UNITED STATES PATENT AND TRADEMARK OFFICE

APPLICATION NO.	FILING DATE	FIRST NAMED INVENTOR	ATTORNEY DOCKET NO.	CONFIRMATION NO.
09/816,671	03/26/2001	Kazunori Matsumoto	43890-504	5732

<b>Office Action Summary</b>	<b>Application No.</b> 09/816,671	<b>Applicant(s)</b> MATSUMOTO, KAZUNORI	
	<b>Examiner</b> McDieunel Marc	<b>Art Unit</b> 3661

**DETAILED ACTION**

FIG. 1

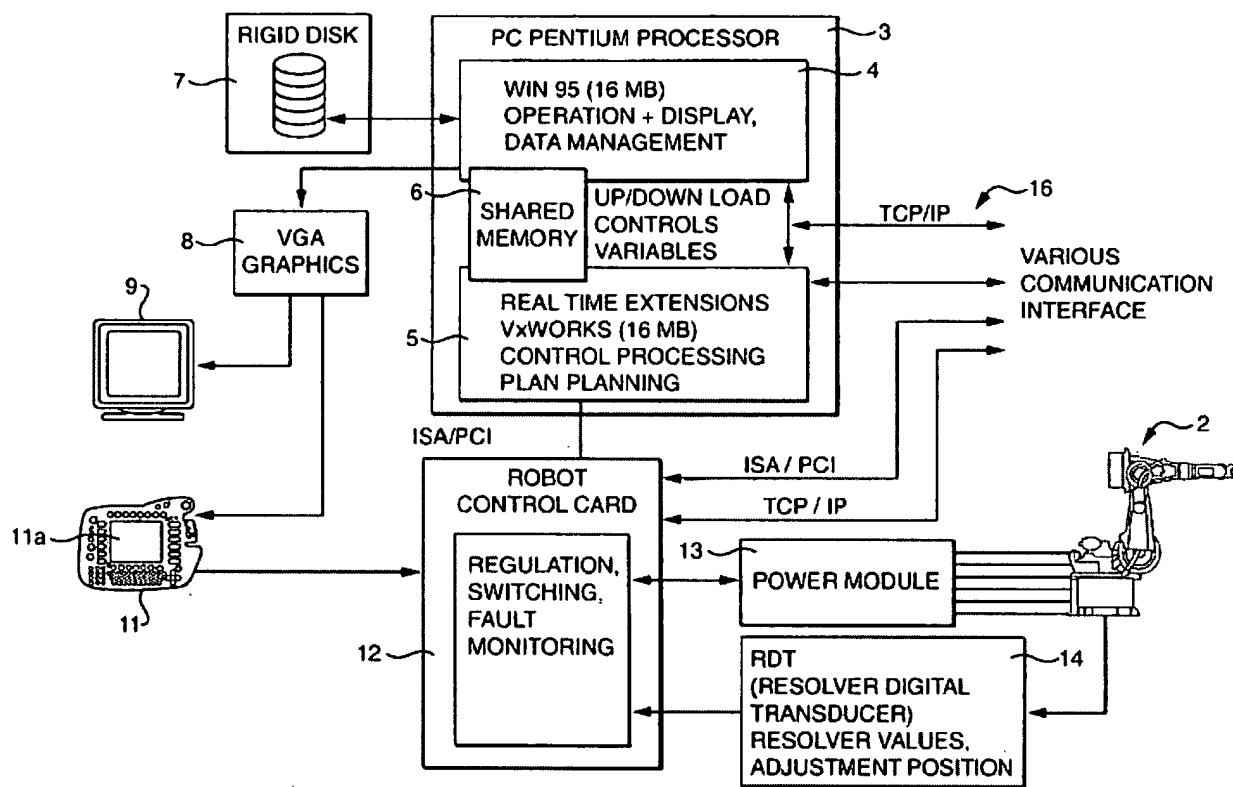
8. Claim 1 is rejected under *35 U.S.C. 102(e)* as being anticipated by **Grob *et al.***, (U.S. Pat. No. 6,356,806 B1).

a robot (see Fig. 1, element 2), please note that element 2 being a KUKA robot body;  
a manipulator to control the operation (see Fig. 1, element 12 and col. 3, line 32), please note that “the robot control card 12 controls the robot 2”, and please bear in mind that element 12 works in collaboration with a standard PC computer as taught by Grob *et al.* as to the limitation of “said robot body” (see Fig. 1, element 2);

a control device (see Fig. 1, element 11) to control said manipulator (see Fig. 1, element 11);

a first path disposed between said manipulator and said control device (see Fig. 1, elements 11, and 12), please note that the arrow being considered as the path between the manipulator and the control device; and

a second path disposed between a commercial power source (see Fig. 1, element 13) and said manipulator (see Fig. 1, elements 13 and 12), please note that the “power module” of Grob *et al.* being considered as a commercial one, since Grob *et al.* discloses a “battery” and “DC voltage using a battery/accumulator” (see col. 4, lines 14 and 67) and the arrow that connects

between elements 13 and 12 of figure 1 being taken for the second path (see Fig. 1, elements 13 and 12).
